## ORIGINATION FORM

Proposed Revisions to a Standard Plans Index  
(Please provide all information — Incomplete forms will be returned)

Index Number: 715-002  
Sheet Number (s): 1  
Index Title: Conventional Lighting

**Summary of the changes:**

INDEX	SHEET
715-002	2 of 8

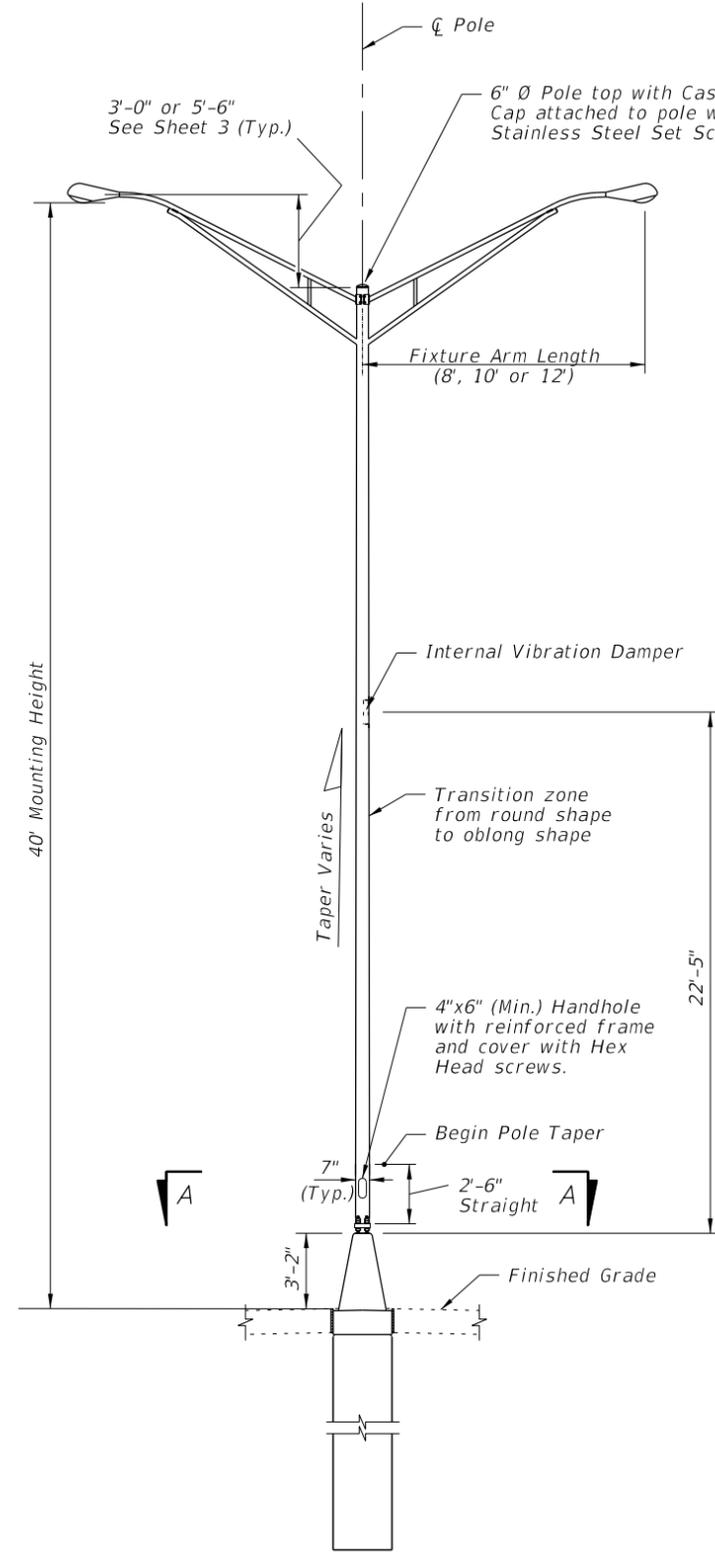
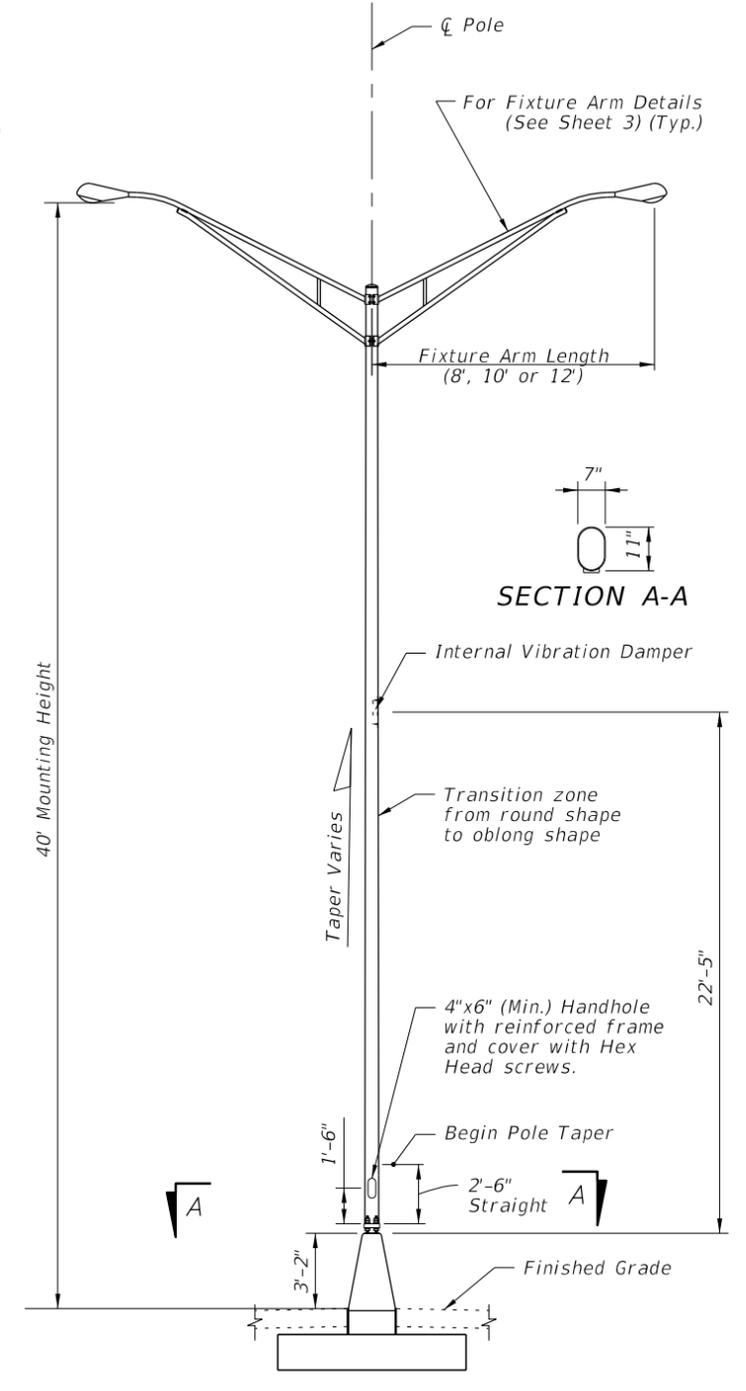
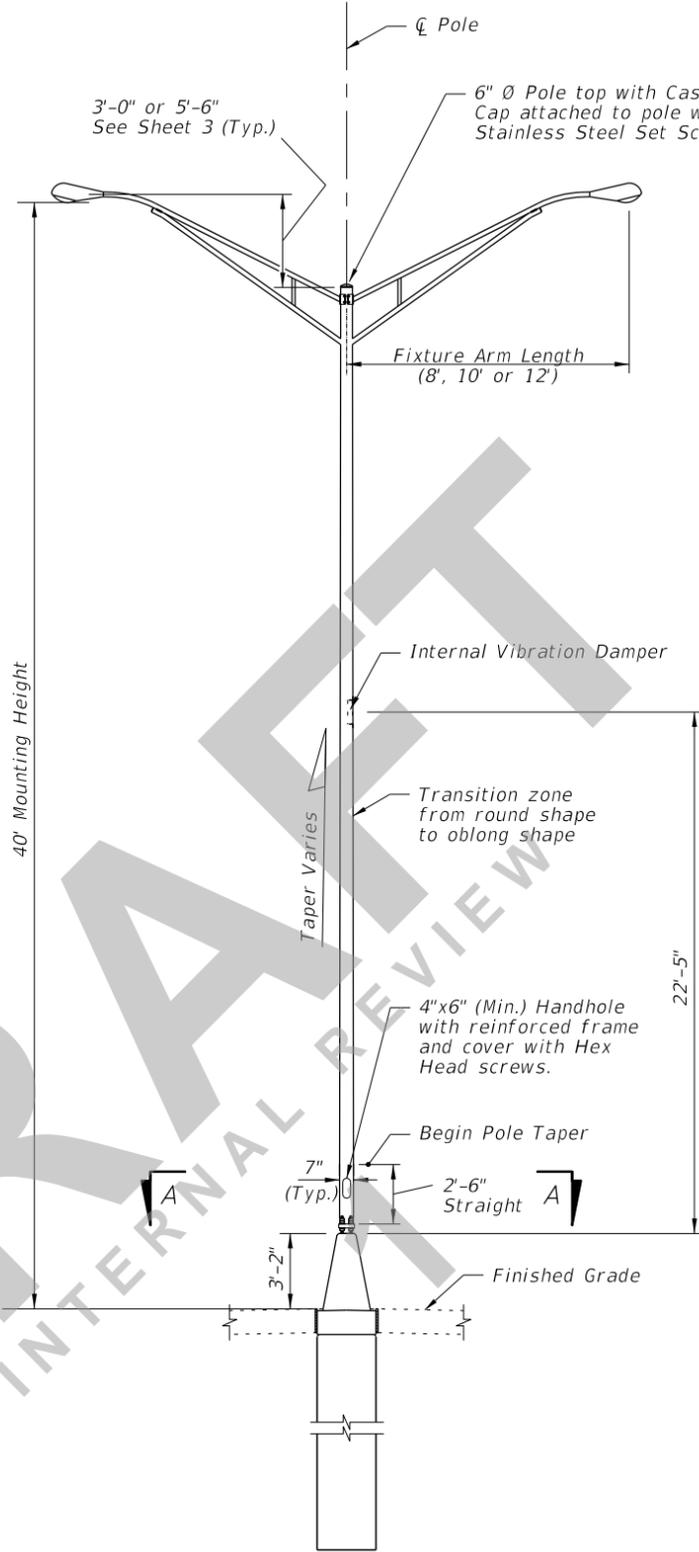
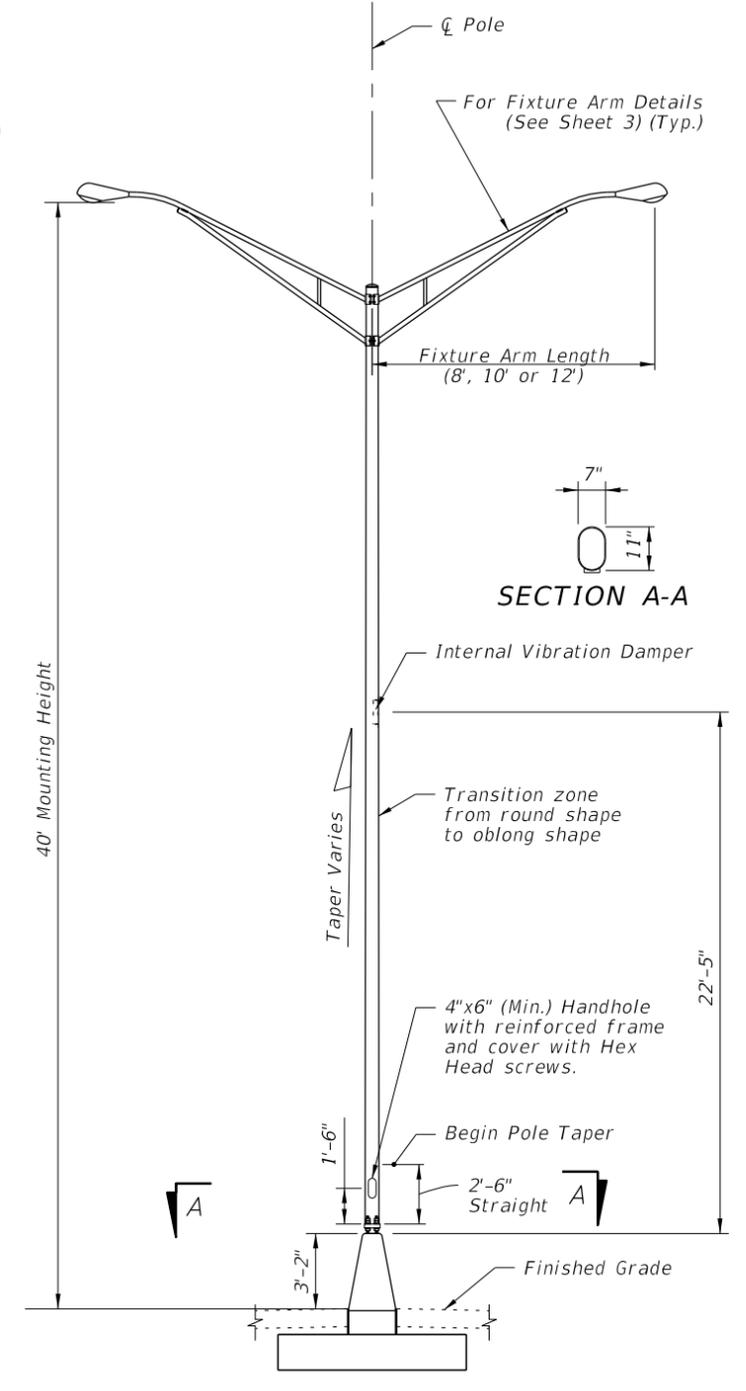
Sheet 2: Clarified that lower luminaire mounting heights of 20' and 25' are for wildlife-sensitive only

Clarified lower mounting heights are for wildlife-sensitive only

20', 25', 30', 35', 40', 45' or 50' Mounting Height
